ADDENDUM NUMBER TWO (2)

Project: MTK – Camp Kamassa
Kitchen/Cafeteria and Infirmary Building
4002 Sumrall Road
Crystal Springs, MS
PN: 19104

FROM: Dean Architecture, P.A.
661 Sunnybrook Road, Suite 140
Ridgeland, MS 39157
(601) 939-7717

1 FLOOR PLAN - BUILDING 1 - LIGHTING
SCALE: 3/16" = 1'-0"

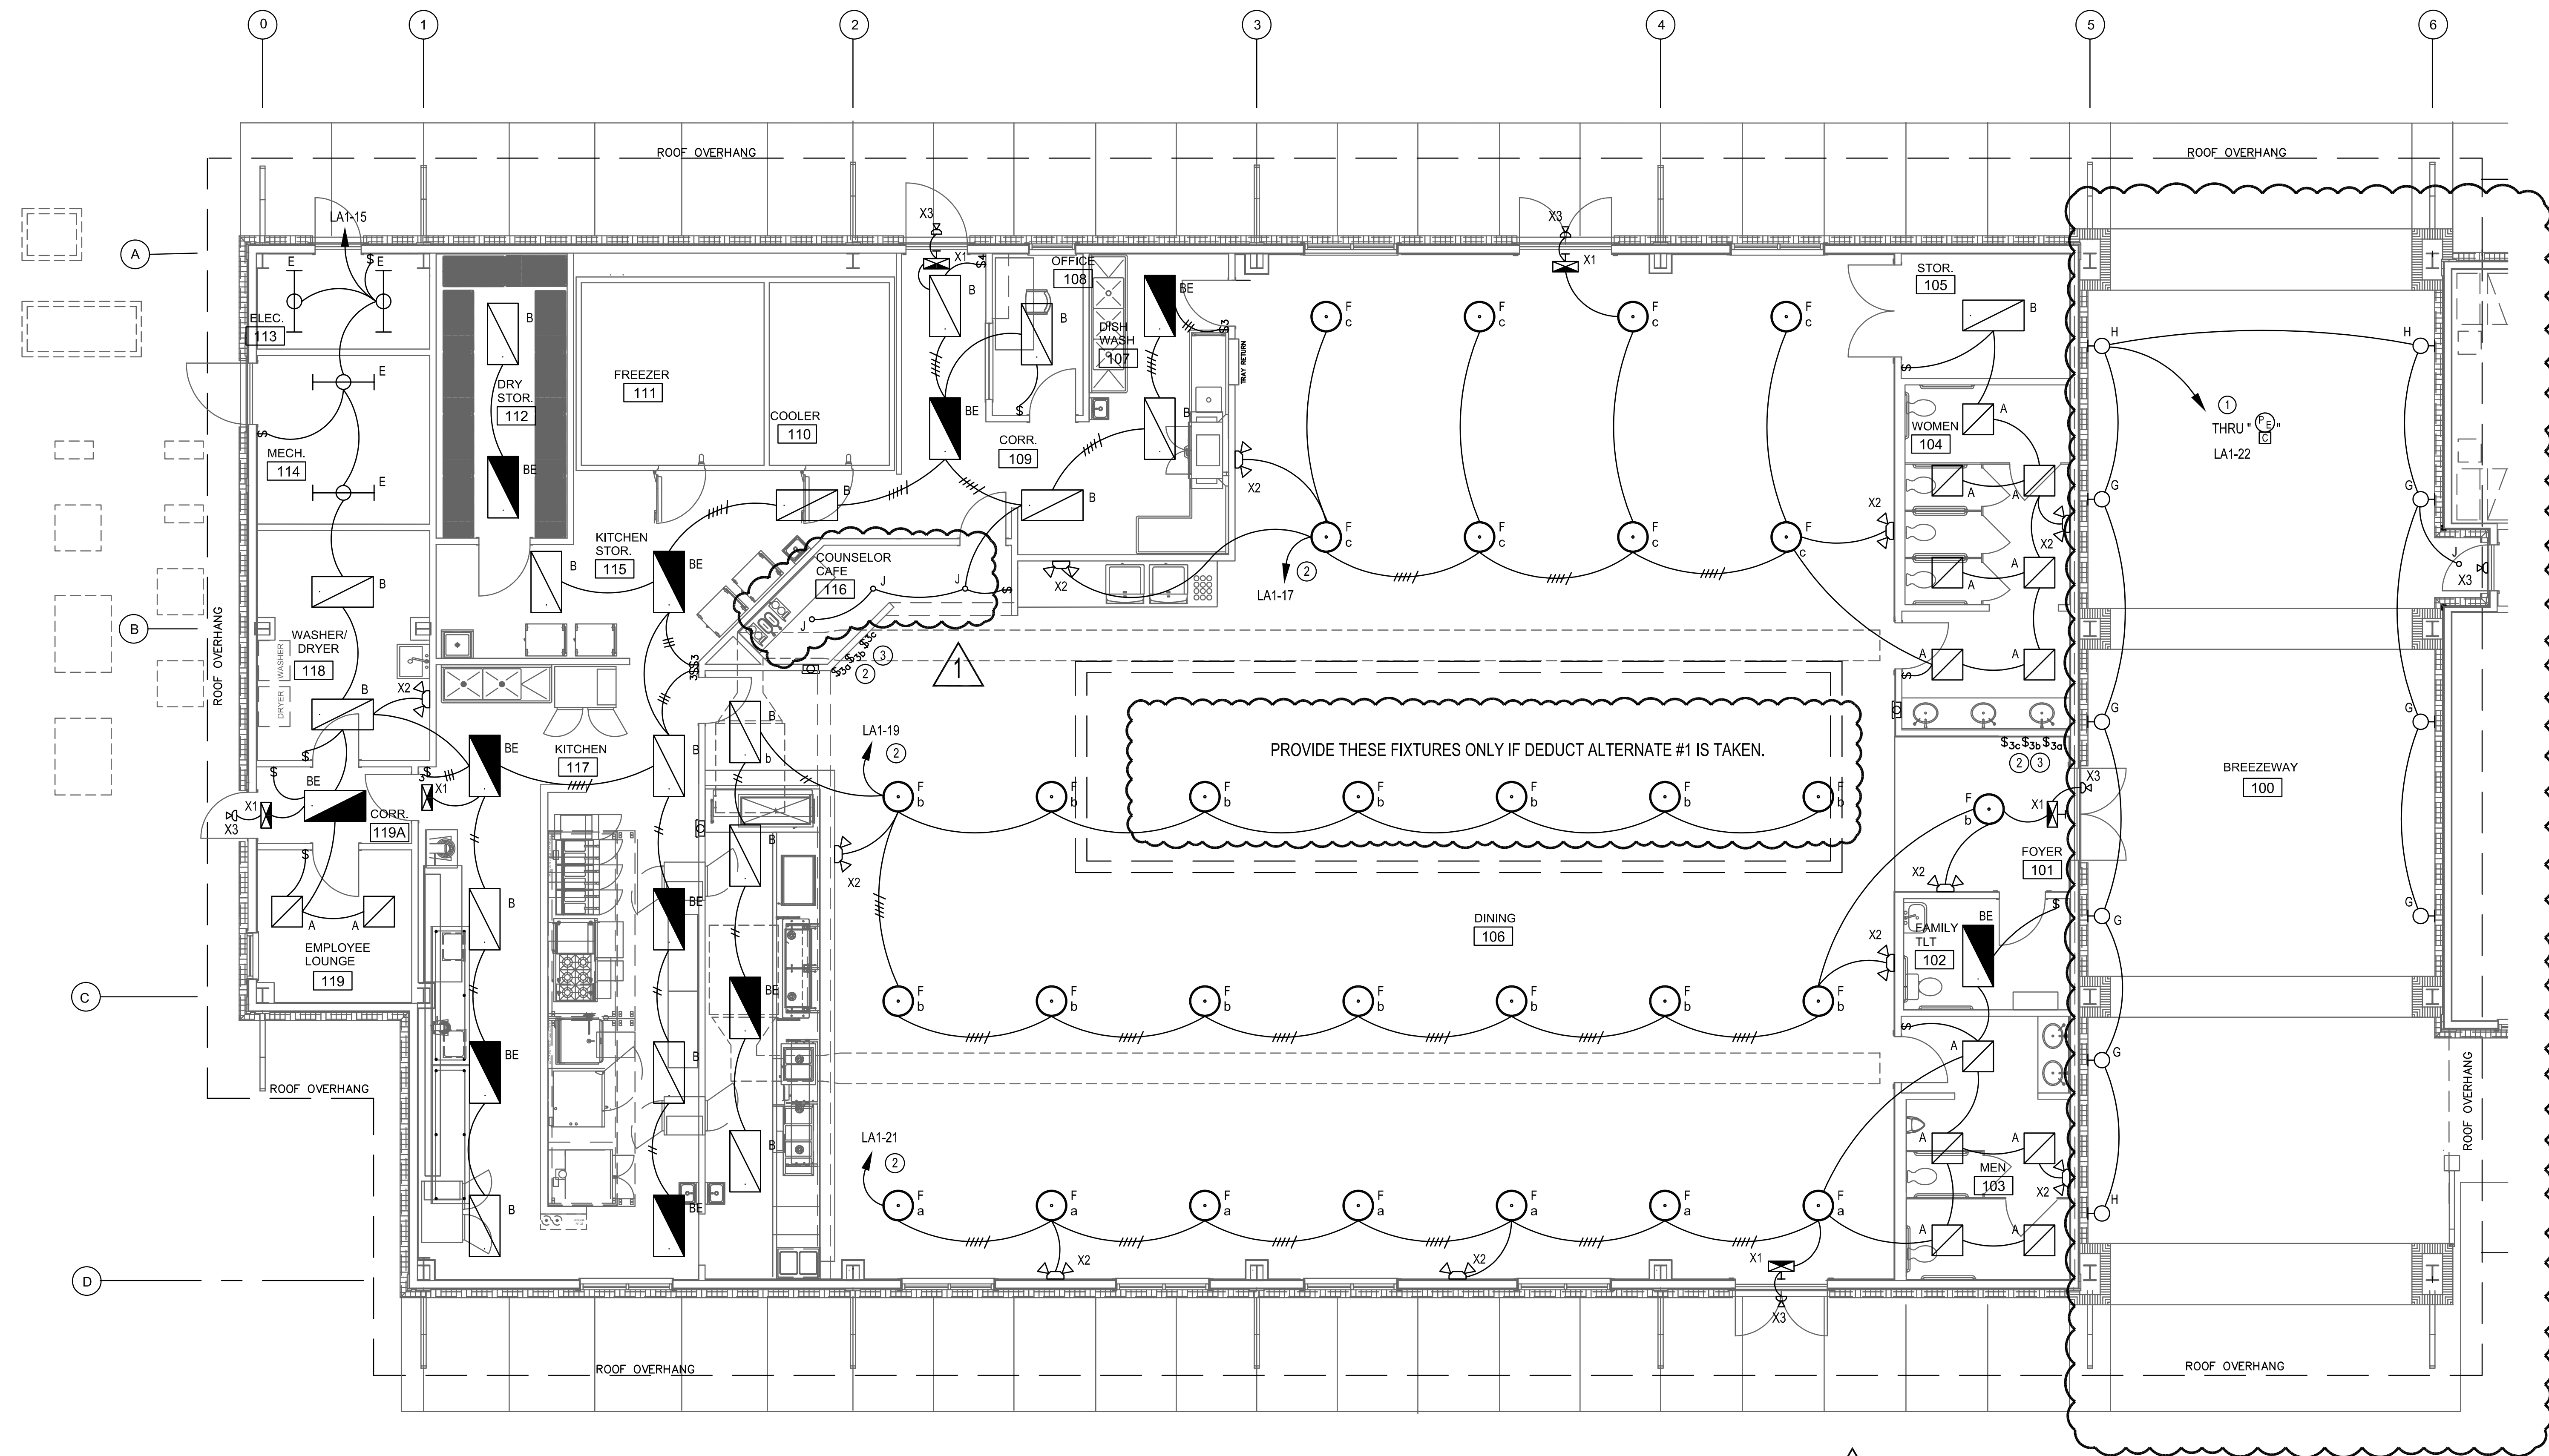
See electrical sheet E101 for added light fixtures in area of clerestory roof if this deduct alternate is accepted.

- Item No. 9: Drawings, Sheet E101R, Lighting Building 1: In Counselor's Café changed fixture type designator; Added General Notes; Revised lighting layout in Breezeway 100.
- Item No. 10: Drawings, Sheet E102R, Lighting Building 2: Revised lighting on Porch 200; Added General Notes.
- Item No. 11: Drawings, Sheet E201R, Power Building 1: Added General Notes; Added 120V circuits for Emergency Generator; Added 120V circuit in Mechanical 114 for sprinkler system air compressor.
- Item No. 12: Drawings, Sheet E202R, Power Building 2: Added General Notes.
- Item No. 13: Drawings, Sheet E203R, Kitchen/Mechanical Connections: Added General Note.
- Item No. 14: Drawings, Sheet E301R, Special Systems: Added tamper and flow switches in Mechanical 114.
